SERVICE BULLETIN

SB No. 69 Issue No. 1

INSPECTION OF ELECTRIC TRIM SWITCH HOLDER

T67M260-T3A and T67 Series Post Mod M443 (Electric Trim).

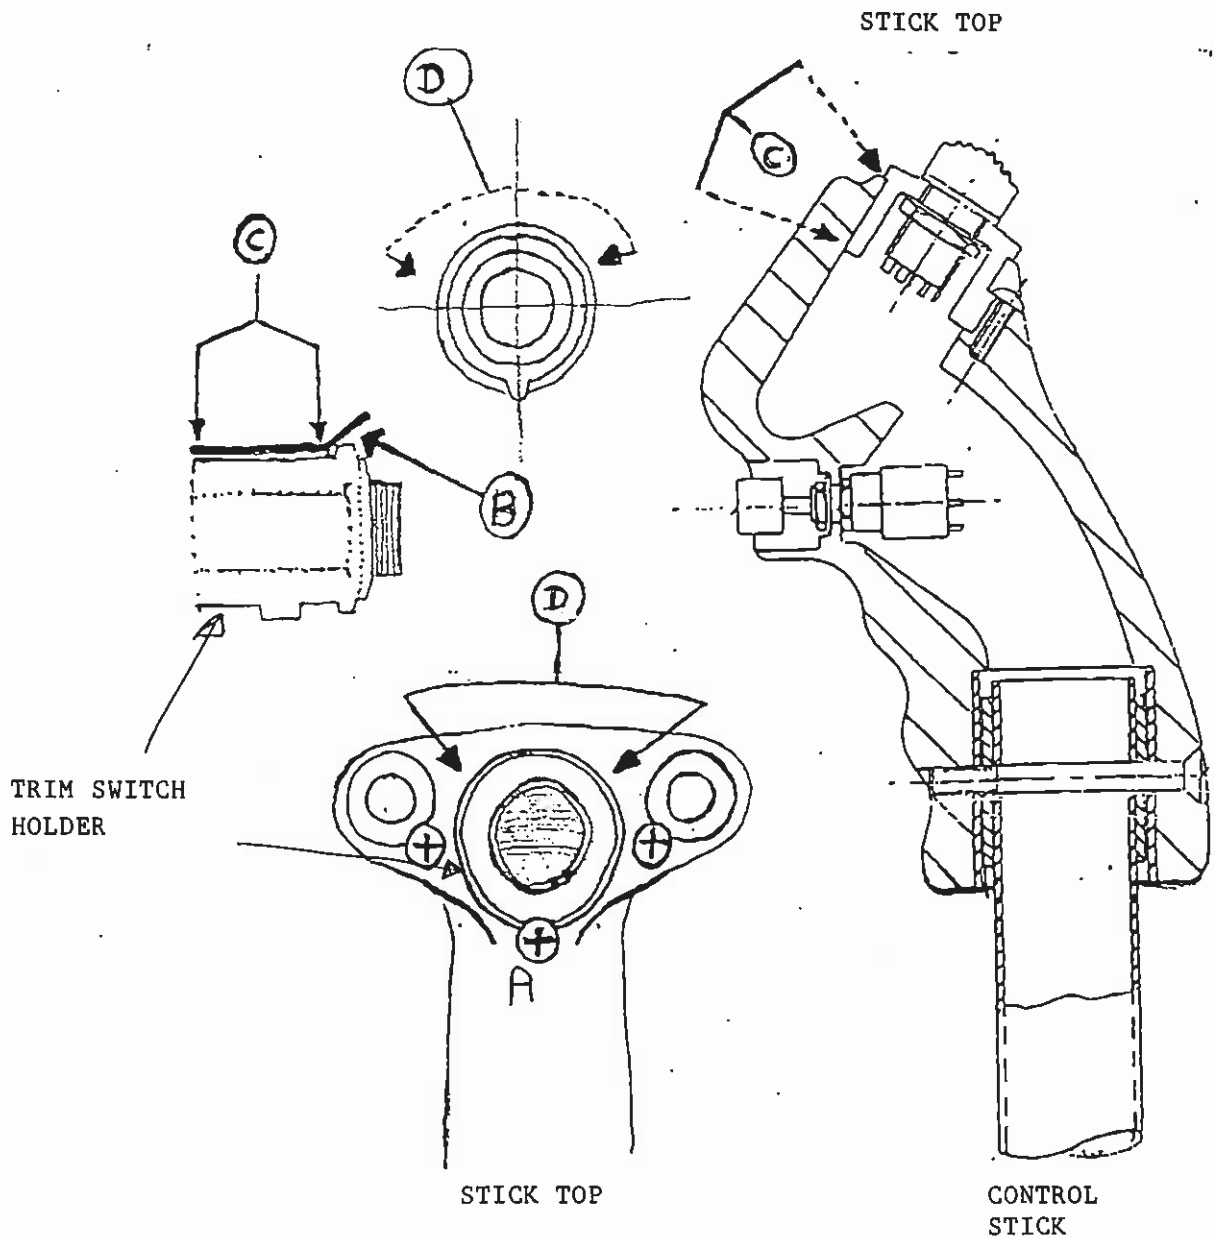
Inspect trim switch holder for fit in stick top.

Often, if the trim switch holder clearance is excessive, the holder will tend to rock upwards at a point opposite the fixing screw. The wires connected to the rear of the trim switch exert the slight force required to cause this.

- 1) Remove central securing screw ('A' on Diagram) and remove holder and trim switch complete being careful not to break wire connections.
- 2) Cut heatshrink (Part No. 126-36-028) to a length so as to allow for handling during installation as illustrated by view B and dimension C.
- 3) Cut heat shrink to width required.

The width of the heatshrink will determine how much shimming will occur around the circumference of the switch. Once it has been determined how wide the heatshrink will need to be for shimming it will be bonded to the switch (See Dimension 'D').

- 4) Bond heatshrink to switch holder using Permabond 126-51-206.
- 5) Trim excess heatshrink flush with shoulder at top of holder.
- 6) Refit holder compete with trim switch into stick top and secure with securing screw 'A'. Take care when re-installing wiring that no wires are trapped or excessively bent, or that connections are not overstrained.
- 7) Annotate aircraft log book "Service Bulletin No.69 complied with".
- 8) If this procedure fails to solve the problem of loose trim switch holder, please contact Slingsby aviation.
